# Imray Correction Notice ICA301

26 February 2025

## Chart **A301** WGS 84

*Edition 2006*

Block correction for A301 (Plan B)  
ILNW 453/18

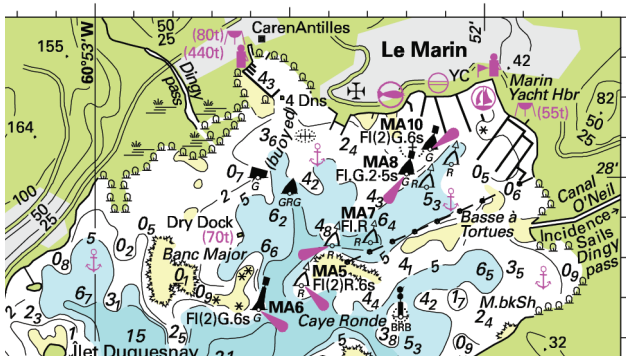
Insert accompanying block correction centred on 14°27'·99N 60°52'·41W (Doyle/Street 9/2018) (ILNW 453/18)
